**Bid #2232**  
**Questions & Answers**

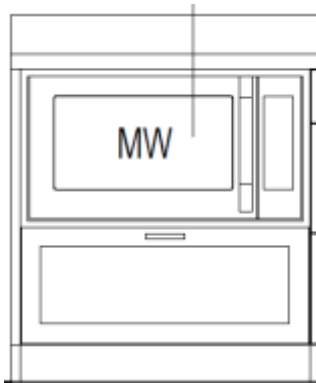
1. Will contractor provide Stove or Owner? There are conflicts on the notes

Answer: ***Provided by contractor.***
